INFORMATION	
PROPERTY RE: SUBMITTED: ARCHITECT: CONTACT:	1510 NE Multnomah St TYPE III DESIGN REVIEW LU 16-291413 DZ March 28, 2018 HOLST Dave Otte, Partner dotte@holstarc.com 503 233 9856
LANDSCAPE: CONTACT:	2.ink STUDIO Tommy Solomon, Associate tsolomon@2inkstudio.com 503 546 4645
OWNER: CONTACT:	Portland Lloyd Center Community LLC Cassidy Bolger bolger.cassidy@gmail.com 503 342 4903

SUMMARY OF UPDATES

PREVIOUS LUR 1 SUBMISSION - NORTH LANDSCAPE SITE PLAN: WHAT WE HEARD

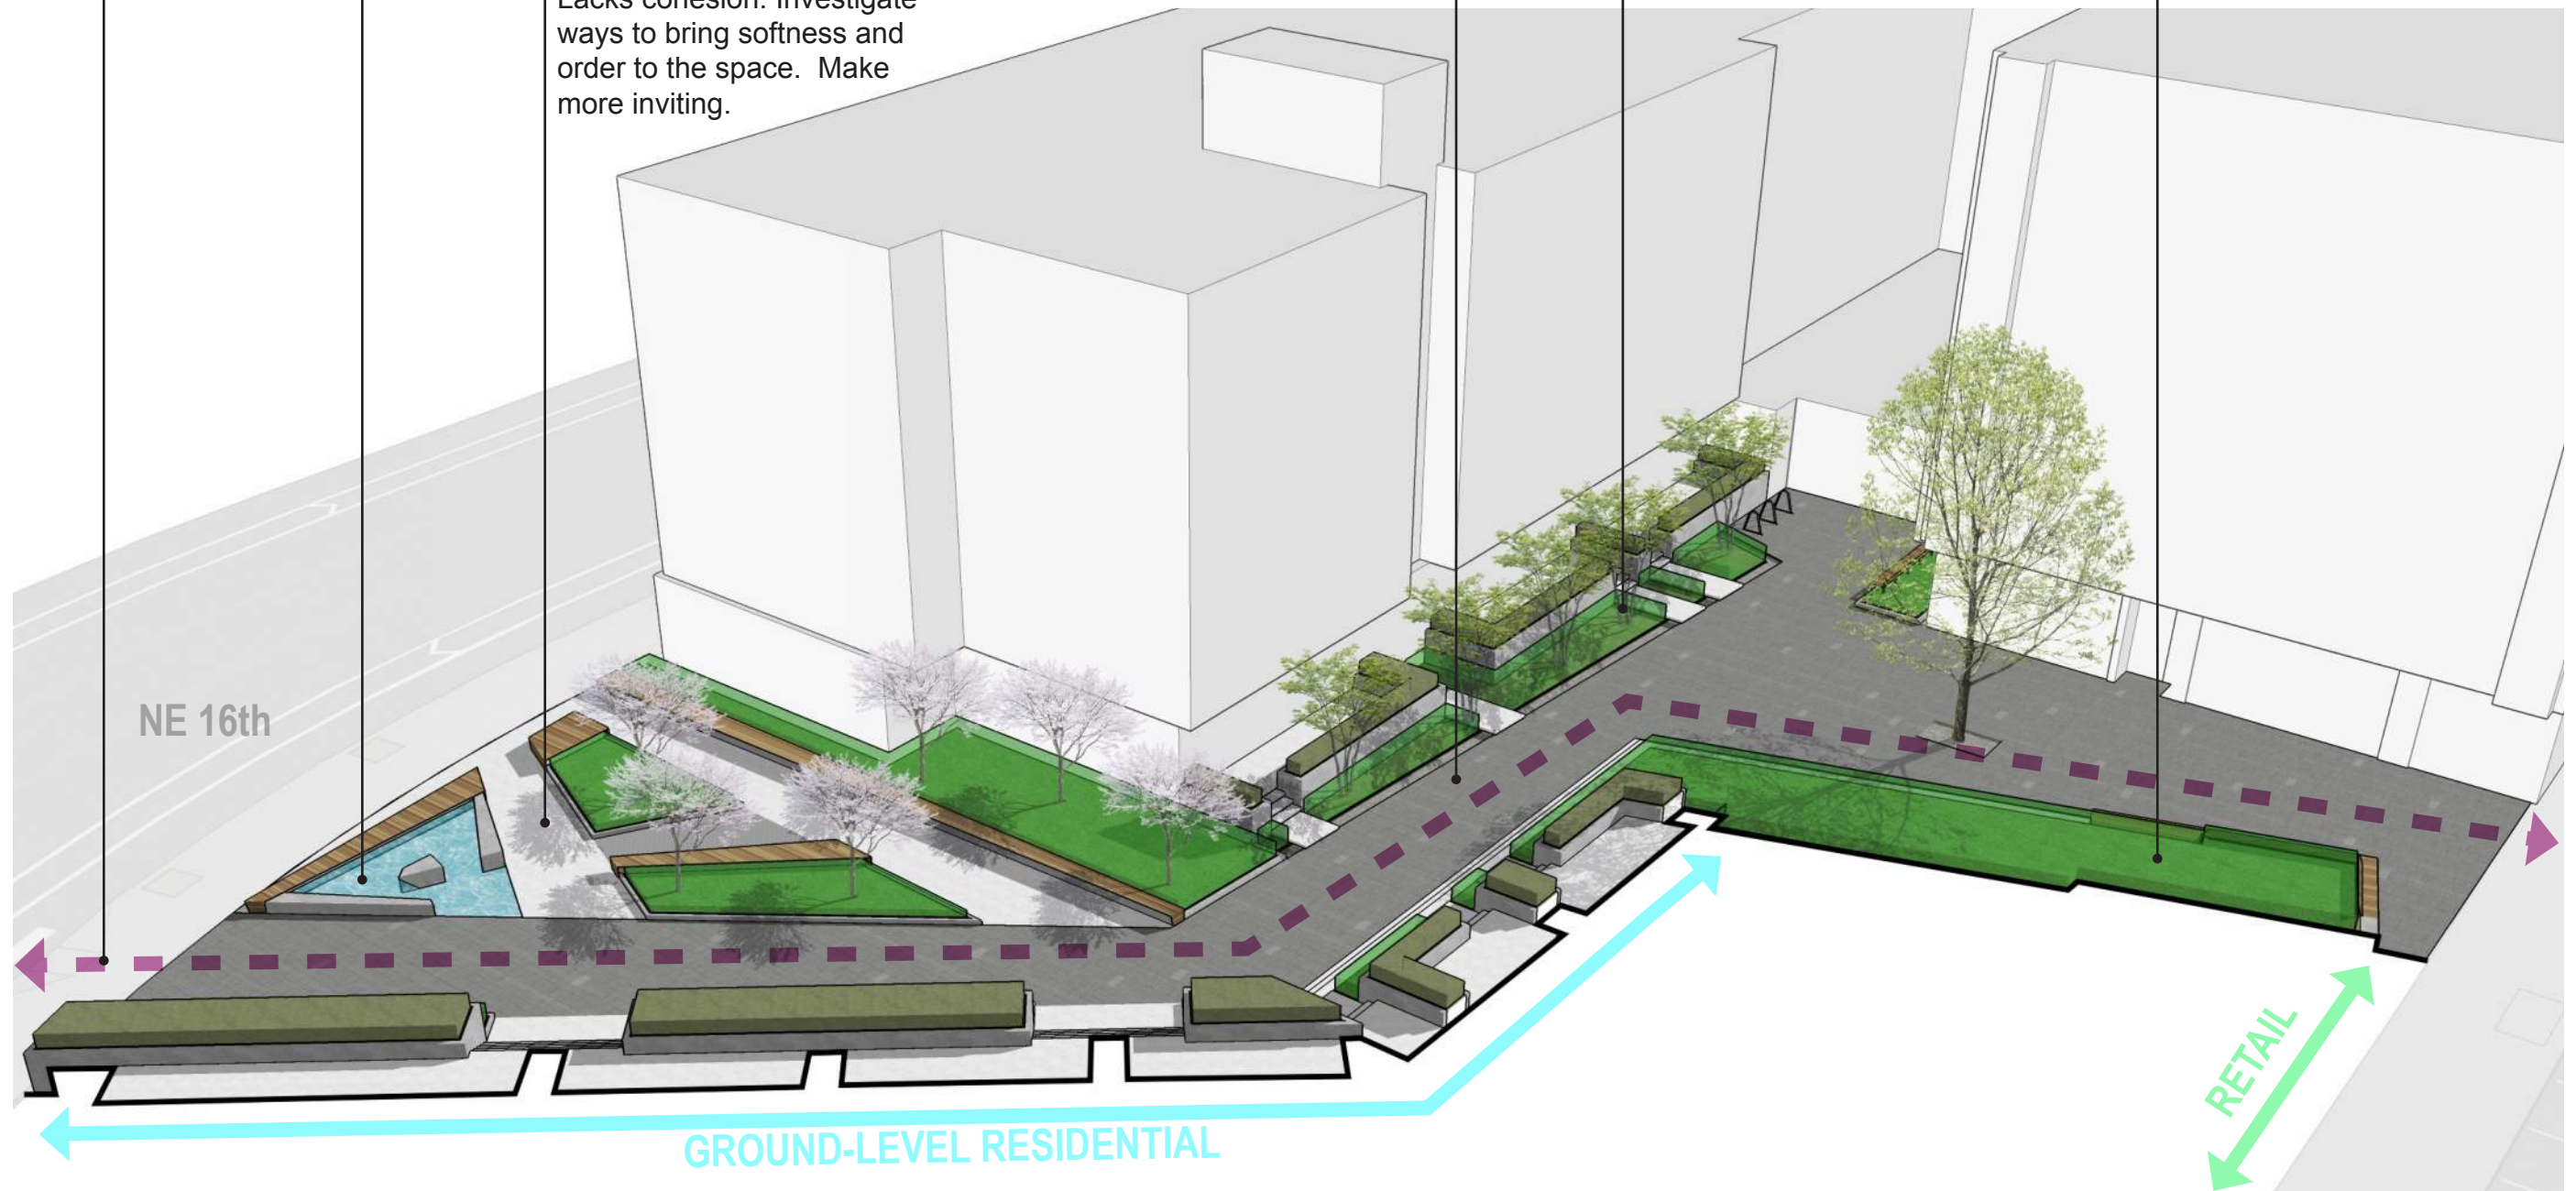
Lack of visual connection is missing. Ensure Neighborhood Passage feels 'safe' (Neighborhood testimony)

Further clarify the intent of the fountain. Is it a landmark? Is it a beacon? Both?

Lacks cohesion. Investigate ways to bring softness and order to the space. Make more inviting.

What is the character? Concern it is not activated enough / feels too private. Investigate Live Work units.

Investigate ways to bring order to the space. Why does this have to be angled?

Deep planter at the north edge feels like a barrier to creating an active plaza. Investigate activating the edges.

LUR 2 - NORTH LANDSCAPE SITE PLAN RESPONSE

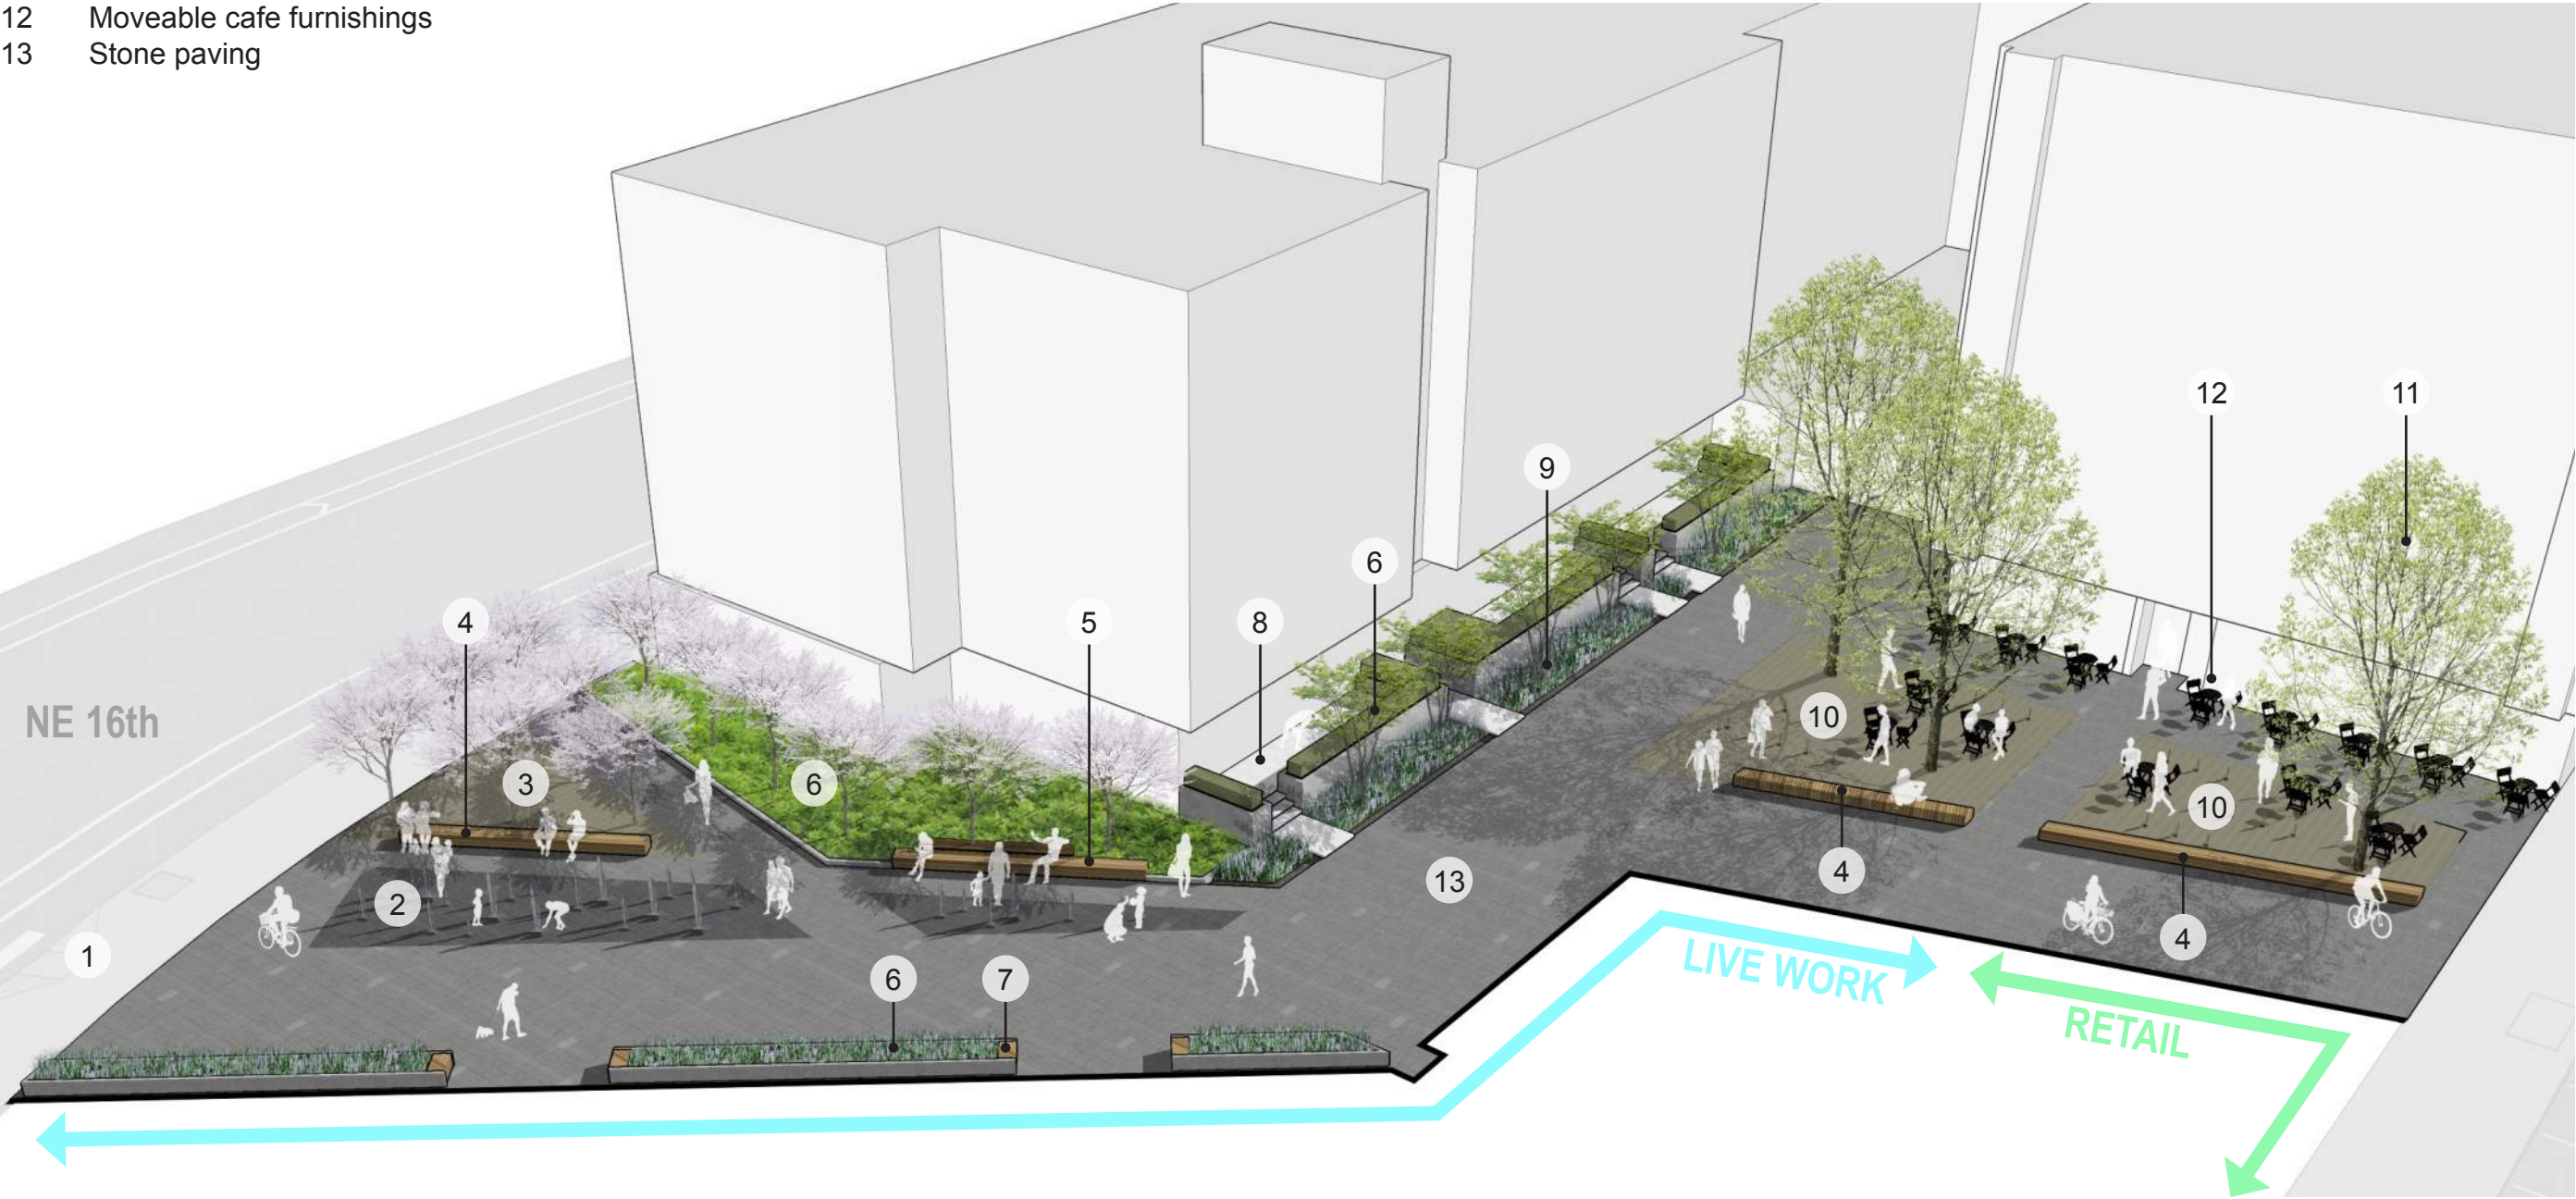
- VISUAL CONNECTION**
Visual connection is missing. Ensure Neighborhood Passage feels 'safe' (Neighborhood testimony)
- FOUNTAIN**
Further clarify the intent of the fountain. Is it a landmark? Is it a beacon? Both?
- POCKET PARK**
Lacks cohesion. Investigate ways to bring softness and order to the space. Make more inviting.
- NEIGHBORHOOD PASSAGE**
What is the character? Concern it is not activated enough / feels too private. Investigate Live Work units.
- POCKET PLAZA**
Deep planter at the north edge feels like a barrier to creating an active plaza. Investigate activating the edges.
- GEOMETRY**
Investigate ways to bring order to the space. Why does this have to be angled?

VISUAL CONNECTION
Buildings and landscape beds have been adjusted to allow for a view from the crosswalk on 16th through the site to the theater along 15th.

FOUNTAIN
The revised fountain provides a meeting place as well as a visual icon for the site and pocket park.

POCKET PARK
Park has been opened up to allow for free flowing movement through stone paving and a tree grove in crushed stone paving. Majority of areas are flush and walkable including the water feature. A planting area flanks the park to the south to create a buffer for the residential units.

NEIGHBORHOOD PASSAGE
The neighborhood passage has been shortened with the architecture on the north building being pulled back. Live/work units now activate the north building face.

POCKET PLAZA
Plaza has been opened up to allow for free flowing movement throughout. Shade trees in crushed stone paving create an active gathering space for the adjacent retail to the south and live/work to the north.

GEOMETRY
Angles in the landscape plan have been refined to provide more clarity of path of travel and spatial edges. Sharp points in the plan have been minimized to create more inviting spaces.

PREVIOUS LUR 1 SUBMISSION - SOUTH LANDSCAPE SITE PLAN: WHAT WE HEARD

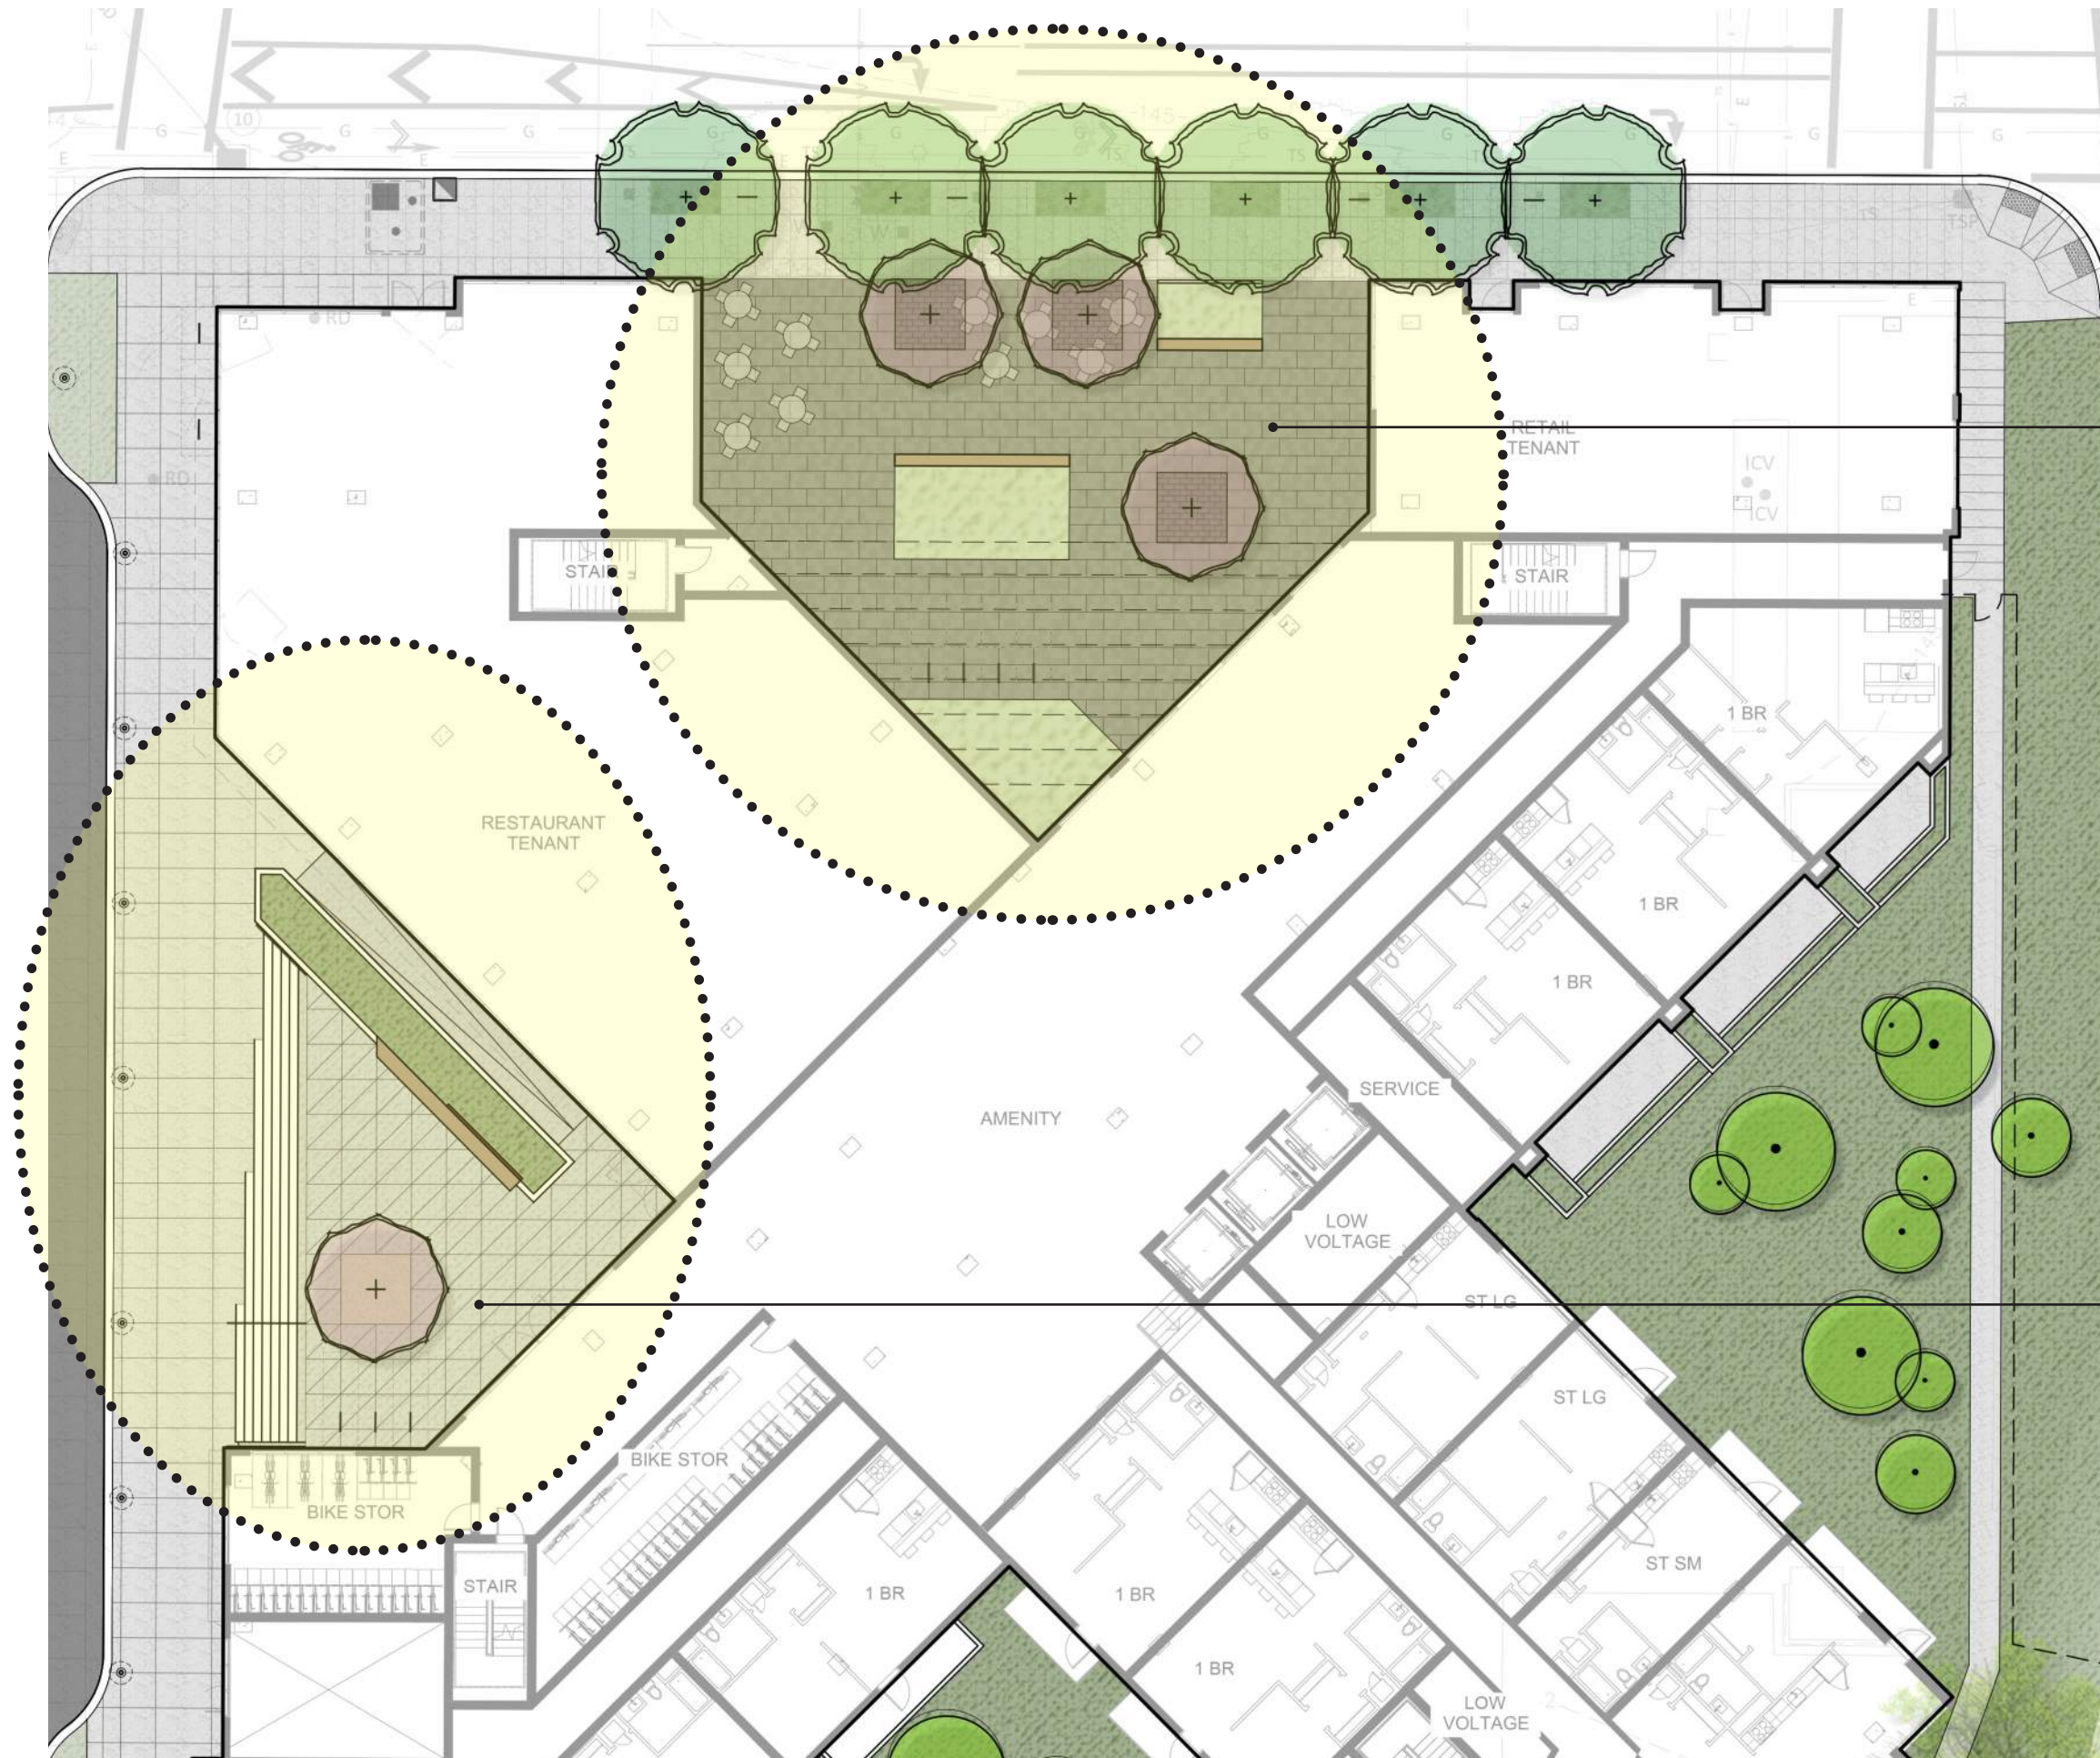
URBAN PLANE PLAZA
Courtyard layout and language doesn't seem quite 'baked'. Landscape design feels too tied to the geometry of the building - investigate some flexibility with layout language. Keep the benches.

PLATEAU PLAZA
Circulation path to Lobby seems too indirect. Linear bench feels like an obstacle and too sharp. Landscape design feels too tied to the geometry of the building - investigate some flexibility with layout language.
